South Texas Project Electric Generating Station 4000 Avenue F – Suite A Bay City, Texas 77414

February 10, 2010
U7-C-STP-NRC-100036

South Texas Project
Units 3 and 4
Docket Nos. 52-012 and 52-013
Response to Request for Additional Information

Attached are the responses to the NRC staff questions included in Request for Additional Information (RAI) letter numbers 299 and 302 related to Combined License Application (COLA) Part 2, Tier 2, Sections 3.7.1, 3.7.2 and 3.8.4.

1/27/10 13:33:08

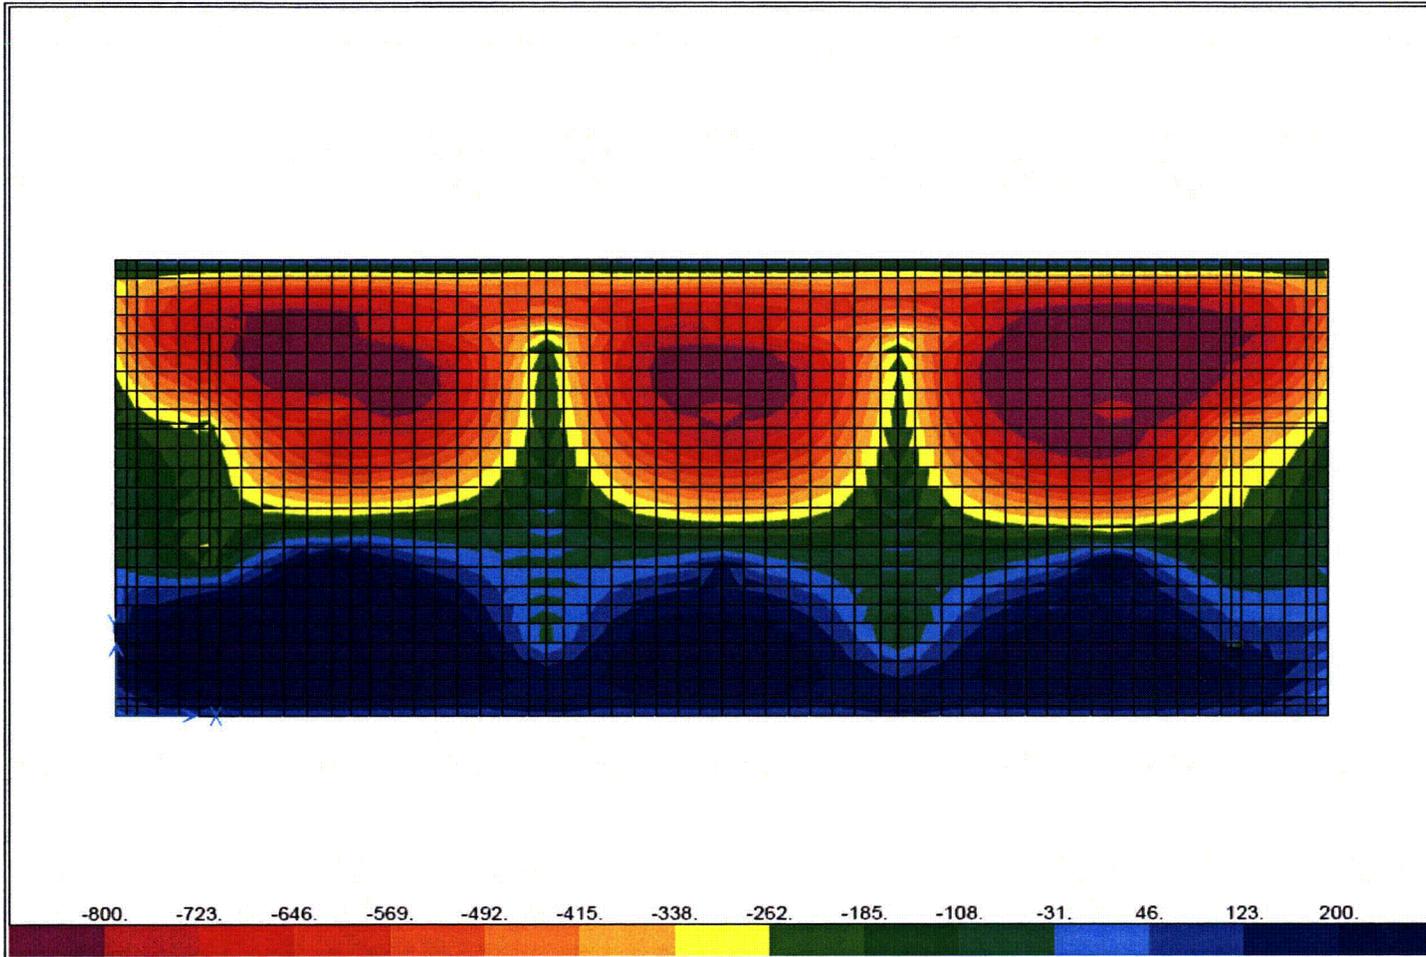
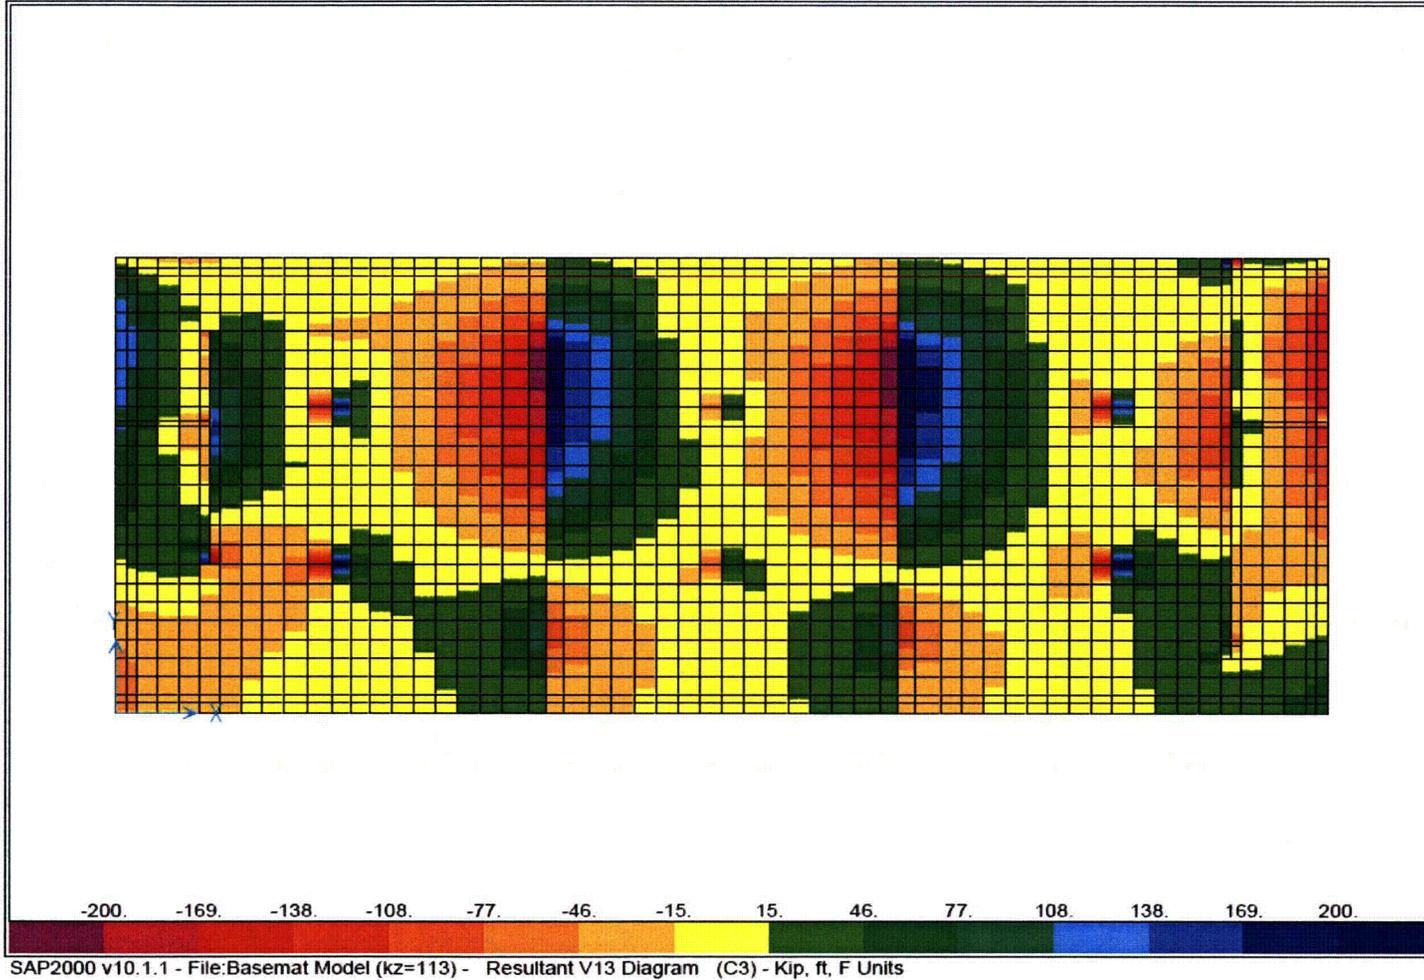
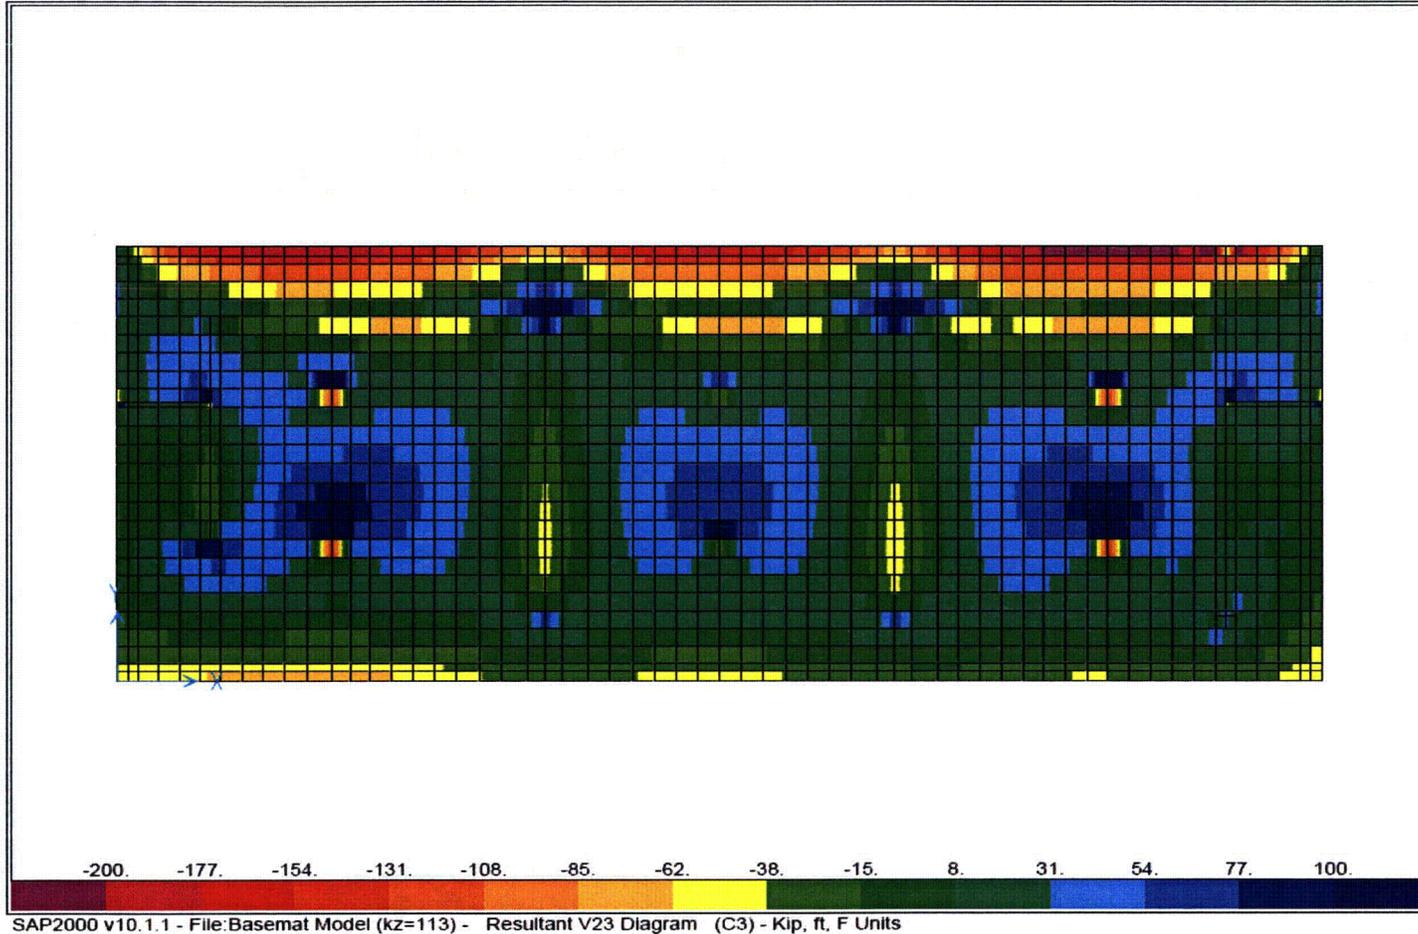
- (1) As shown in Table 2 in the response to RAI 03.07.01-7, a Poisson's ratio equal to 0.46 to 0.48 is used for calculating the soil spring constants that are used for the settlement evaluation and mat design. This high Poisson's ratio assumes that the vertical stresses transmitted to the saturated foundation soils are resisted by the incompressible pore water. Nonetheless, depending on the foundation soil permeability, the excess pore water pressures can dissipate quickly; thus, transferring the stresses to the soil grains. In light of the above, the applicant is requested to provide a comparison of the soil spring constant values, calculated using drained Poisson's ratio of foundation soils, with those of the ABWR DCD and justify any differences as to their effect on mat design forces.

- (2) In the response to RAI 03.07.01-7, the applicant stated that "*The spring constant values are provided only for the Reactor Building in the DCD. Therefore, a comparison of the spring constant values is provided only for the Reactor Building.*" This justification for not evaluating the effect of site-specific shear wave velocity on the Control Building (CB) foundation design is not acceptable. The applicant is requested to further justify that the design of the CB foundation at the STP site would still be bounded by the standard plant CB design.

As noted in part (2a) of this response, the calculated STP site-specific soil spring constants for the upper range and best estimate cases are the same as, or higher than, the best estimate soil spring constants used for the standard design. Higher soil spring constants at the STP site will result in mat design forces smaller than those used for the ABWR CB design. The lower range site-specific soil spring constants are lower than the best estimate DCD spring constants. However, even with lower range site-specific spring constants, the ABWR CB mat design is adequate for the STP site for the following reasons:

- Considering the size and geometry of the CB, arrangement of the exterior and interior shear walls, thickness of the shear walls (39 inch exterior walls and 63 inch interior walls), and the mat thickness (i.e. 118 inches), the CB mat design is quite rigid and not so sensitive to spring constant values. This can be seen from the parametric study results presented in Figures 03.07.01-20a through 03.07.01-20i provided with this response.

Figure 03.07.01-20a shows the layout of the mat and the shear walls of a structure with very similar arrangement to that of the DCD CB. The model used for this parametric study is a three dimensional finite element model. This model was analyzed twice for the total dead load of the structure along with significant seismic moment about the X-axis (along East-West), once with DCD best estimate spring constants and the second time with lower bound site-specific spring constants. Figures 03-07-01-20b through 03-07-01-20e present contour plots of the resulting out-of-plane moments and shears when using DCD spring constants. Figures 03-07-01-20f through 03-07-01-20i present contour plots of the resulting out-of-plane moments and shears when using lower range site-specific spring constants. Comparison of the resulting out-of-plane moments and shears from these two cases show that there is no significant change in mat design forces.

Figure 03.07.01-13a

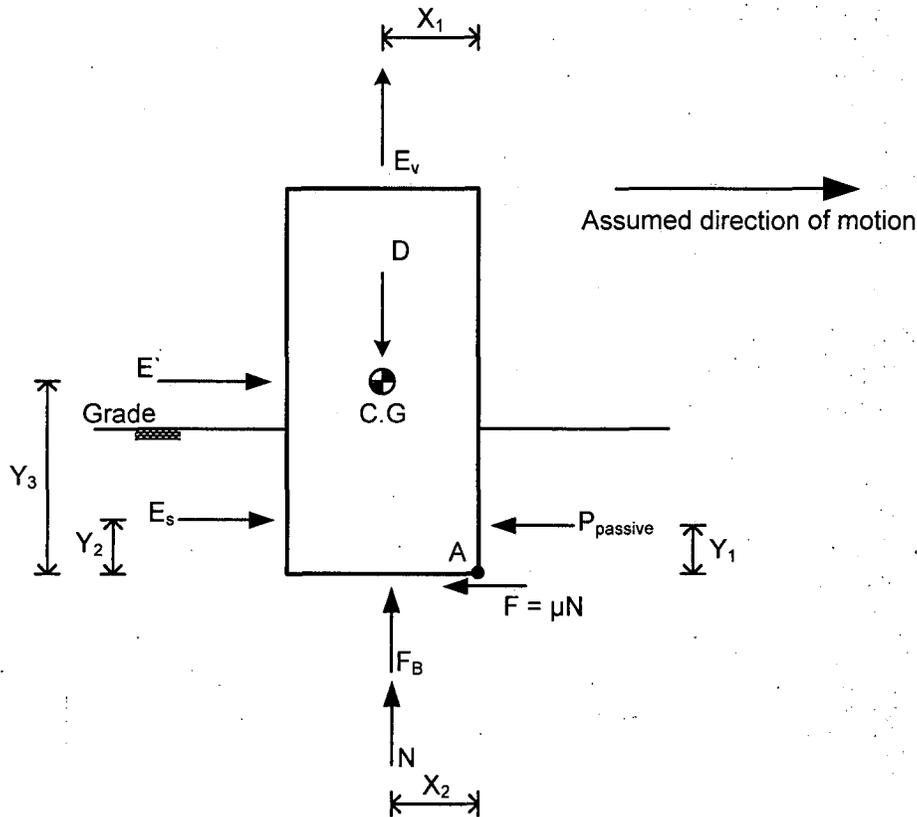
2. The response to item (c) of RAI 03.07.02-1 indicated that non-Category I structures with the potential to interact with Category I structures have not yet progressed to a point where sliding and overturning potential as a result of the SSE can be evaluated. However, as identified in SRP guidance 3.7.2I.8., the staff must review the applicant's seismic design of these non- Category I structures. As such, the applicant is requested to provide in the FSAR factors of safety against sliding and overturning including the basis of coefficient of friction used in the analysis during an SSE for Turbine Building, Radwaste Building, Service Building, Control Building Annex, and Plant Stack.

- Sliding and overturning evaluations are performed as shown in Figure 03.07.03-13a.
- Coefficient of friction for sliding evaluations for the four buildings shall be based on site-specific soil conditions.
- For simultaneous application of seismic forces in three directions the 100%, 40%, 40% combination rule as shown below will be used:

Figure 3H.6-40: SAP Finite Element Model for UHS and RSW Pump House Design

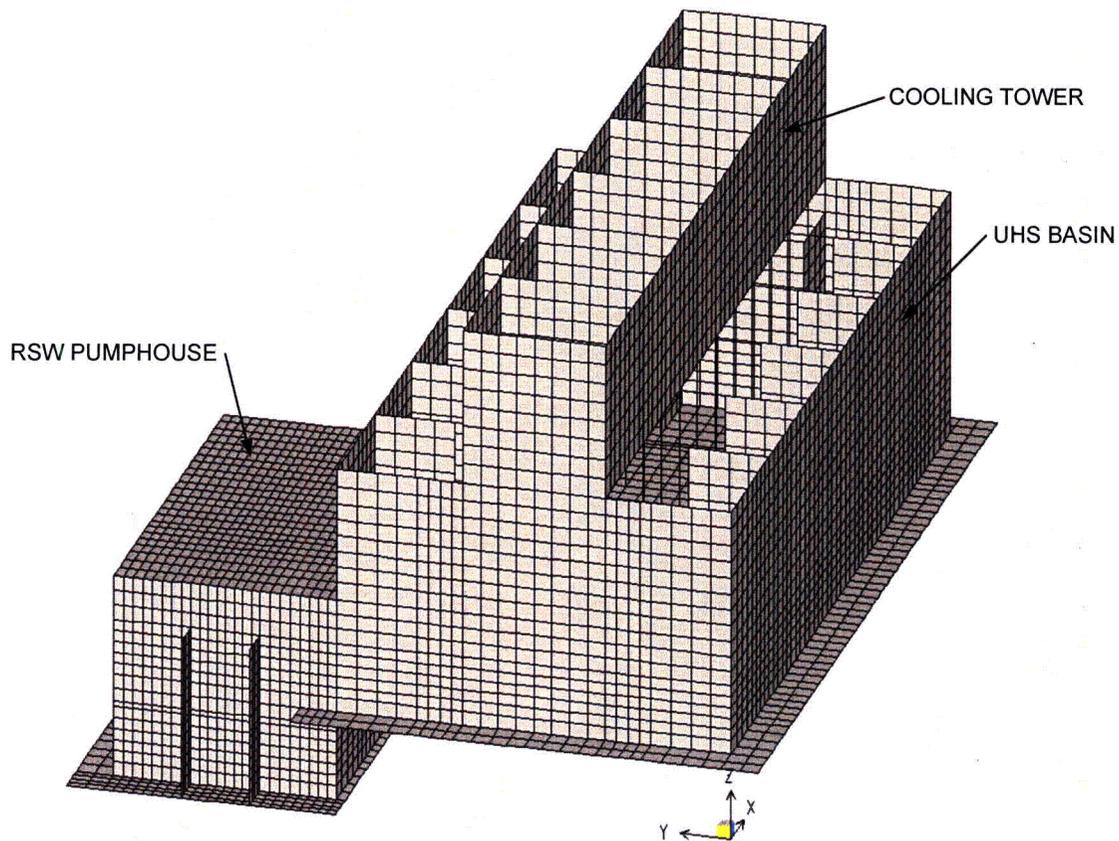
1. The finite element model referenced in Figure 3H.6-40 (this figure is not yet available in the response to RAI 03.07.01-13).
2. Method used to model the backfill material in the SSI analysis.
3. Method used to incorporate the ground water effects in the SSI analysis.
4. The analysis method used to obtain the seismic forces and moments for design evaluations.
5. The analysis method used to model concrete cracking.
6. The analysis method used to assess the effects of soil separation from the walls.

1. Figure 3H.6-40 was provided as part of the Supplement 1 response to RAI 03.07.01-13 (see letter U7-C-STP-NRC-090208 dated 11/19/2009) and for convenience is reproduced below. For additional information and figures for the Soil-Structure Interaction (SSI) analysis model of the Ultimate Heat Sink (UHS) and Reactor Service Water (RSW) Pump House, please see the response to RAI 03.07.02-16 submitted concurrently with this response.

Figure 3H.6-15: SASSI2000 Model of UHS and RSW Pump House

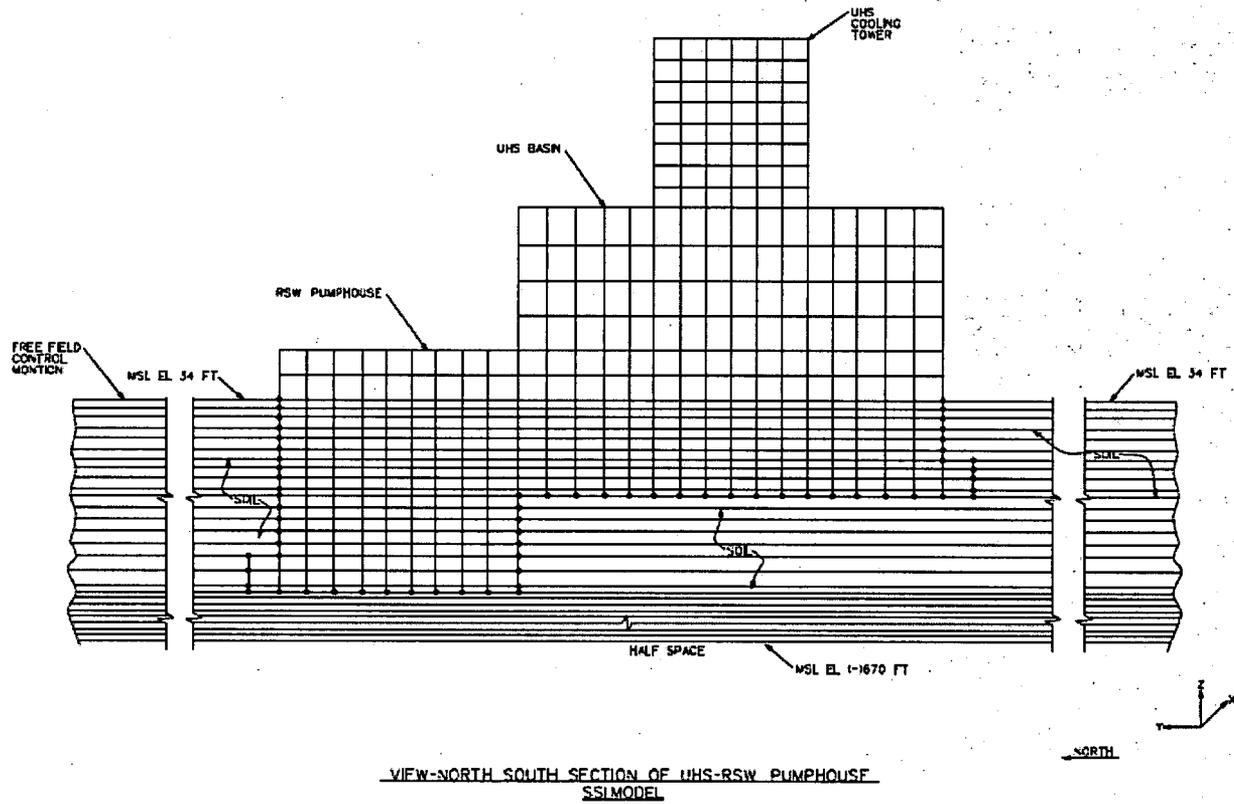
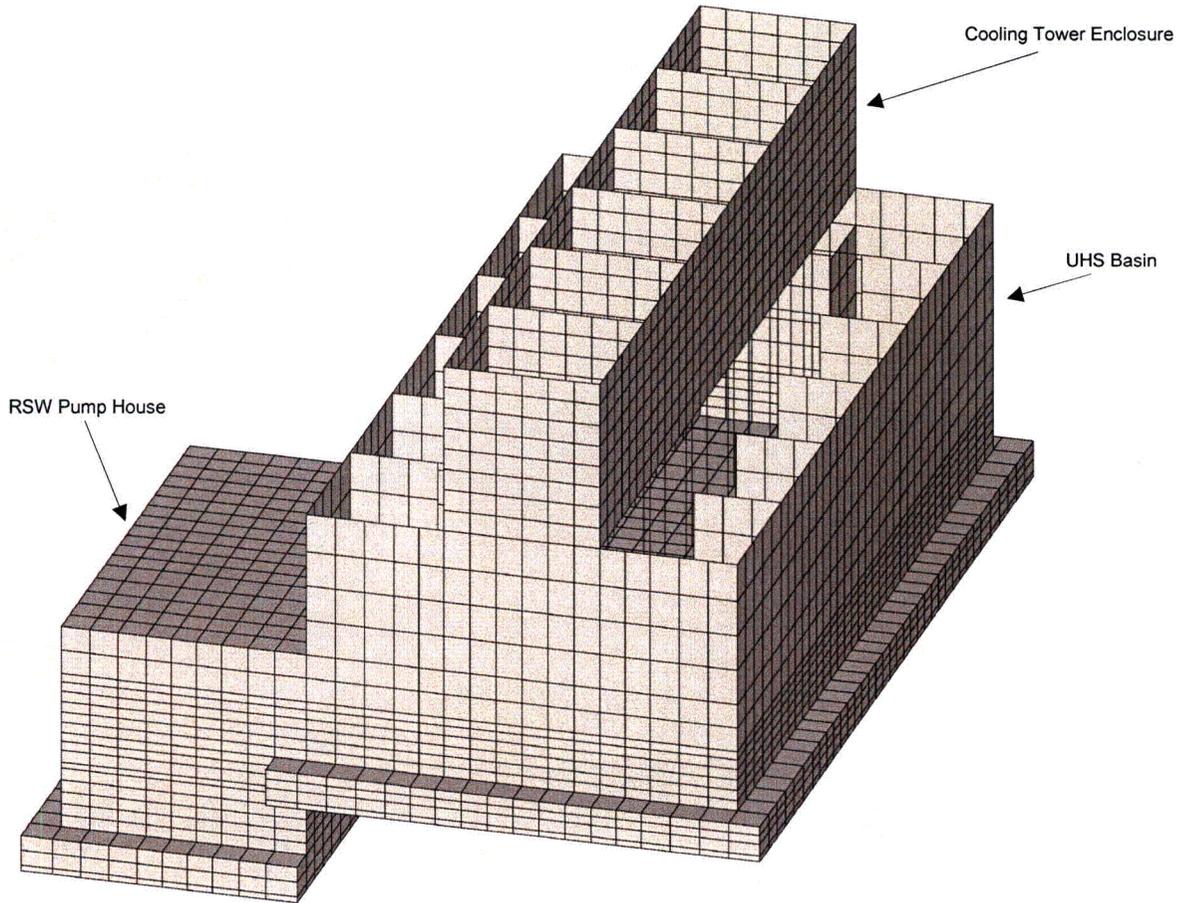
7. A figure showing the finite element model of the structure in relation to the layered soil system.
8. A description of how the ground water effects were treated in the SASSI2000 model.

7. Figure 3H.6-15 showing the north-south cross-section of the three-dimensional finite element model of both structure and soil layers was provided as part of the Supplement 1 response to RAI 03.07.01-13 (see letter U7-C-STP-NRC-090208, dated 11/19/2009) and for convenience was reproduced in part 3 above. For additional information and figures, please see the response to RAI 03.07.02-16 submitted concurrently with this response.
